SERVICE BULLETIN

NUMBER: 05-88-21

SUBJECT: Front Stabilizer Bushing- Design Change
Knocking / Squeaking Sound

**Front Stabilizer Bushings
2 per Vehicle**

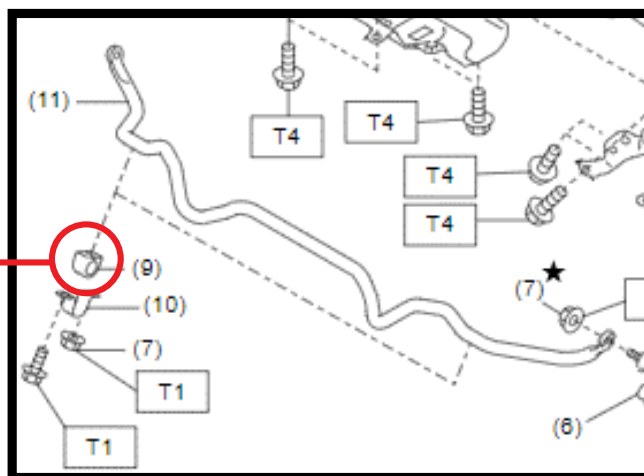
This bulletin announces a design change made to the front stabilizer bushings. The bushing material has been enhanced to address knocking / squeaking sounds when driving on rough roads during low ambient temperatures. If confirmed under the described driving conditions, the bushings shown in the illustration below should be replaced.
